ADDENDUM 6

Contract: 23-C-00013; Morris Bridge Filter Building Improvements ReBid

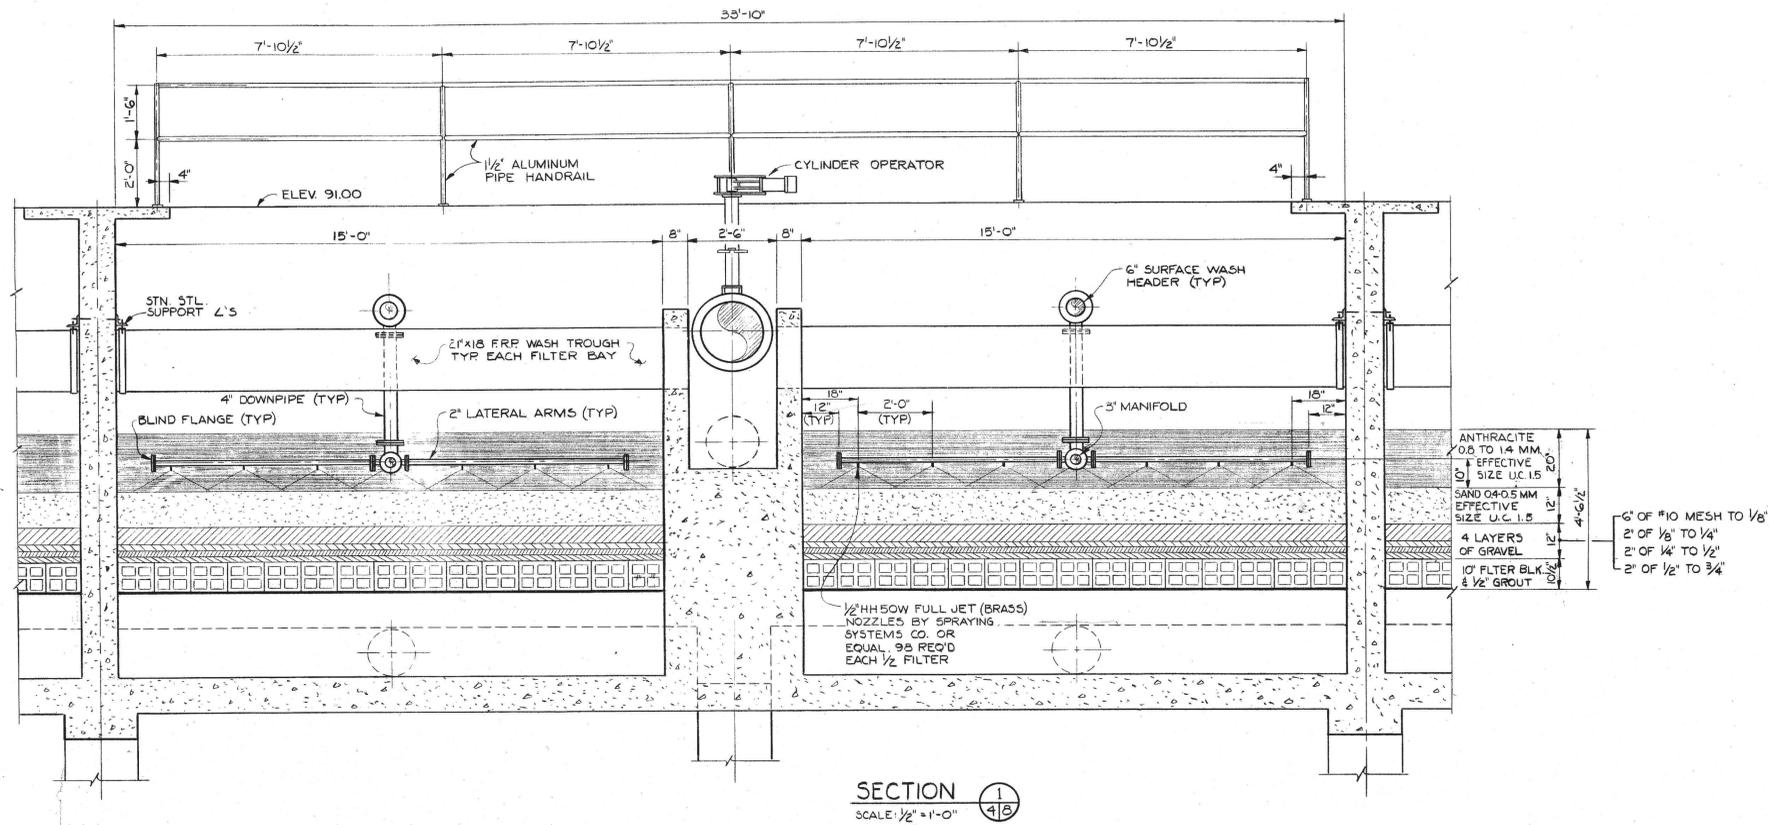
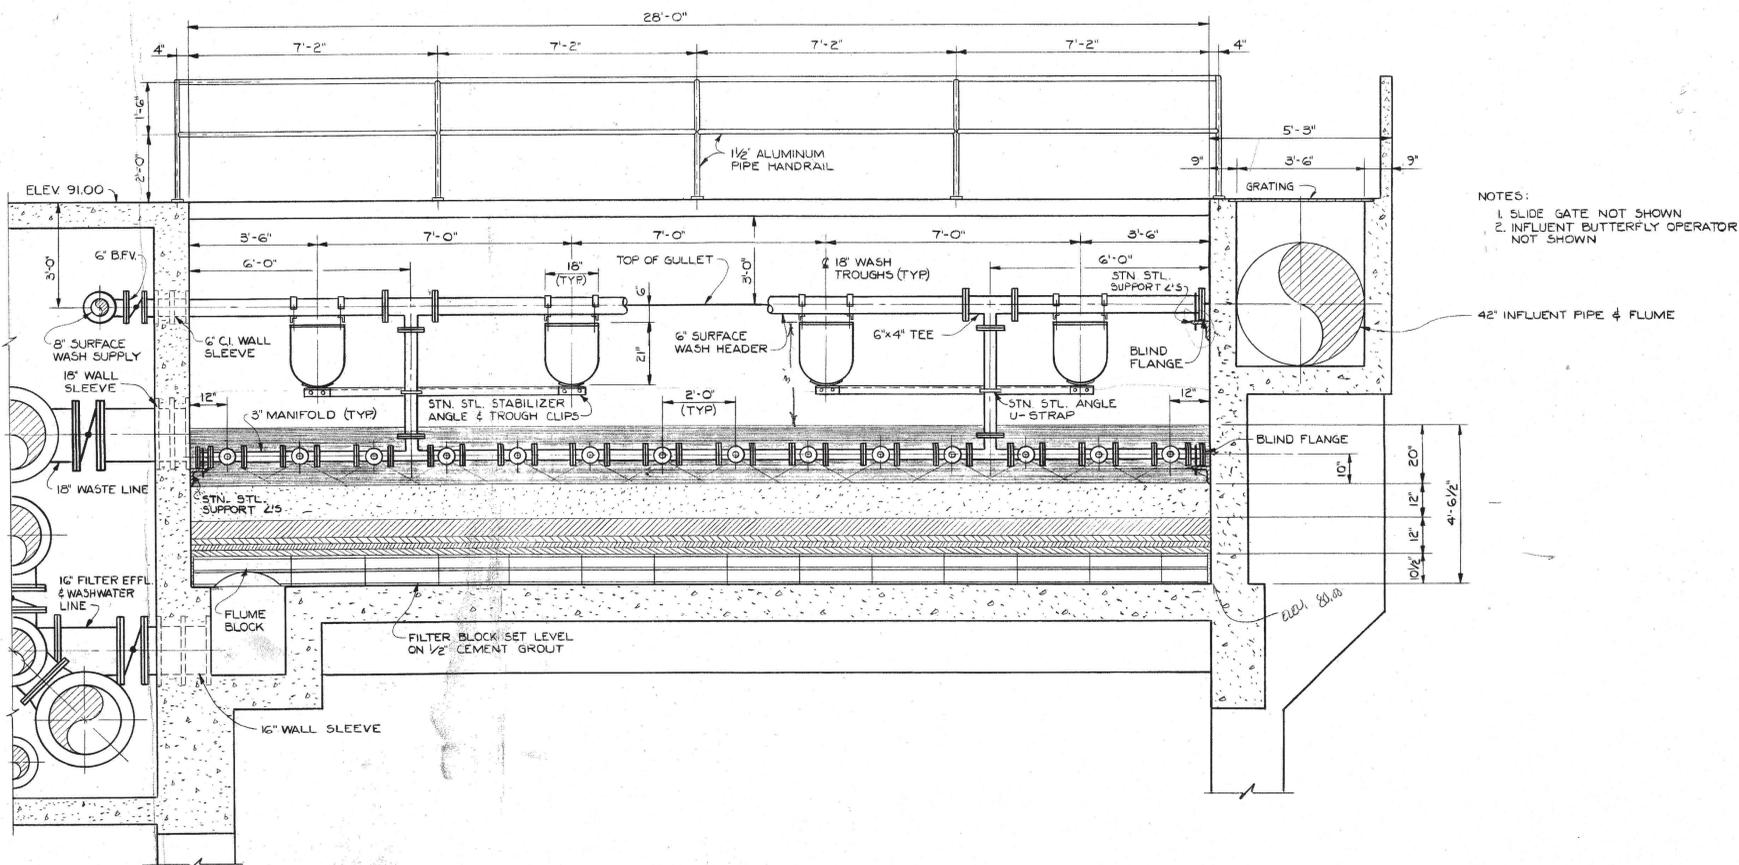
3. In addendum #4 question #1 asked for cross section of filter tank? Answer - c. contractors to use mean and methods to demo work of tanks sub floors. We still don't have detail of how the clay tile/brick are installed and supported structure. Can't estimate without know how it was built. Or does this abbreviation PV in pricing sheet 18 deal with as a allowance?
See attached as-built.

4. How many drains are per filter tanks and is there any way for a color pipe chart layout for these?
See attached as-built. Color pipe chart layout not available.
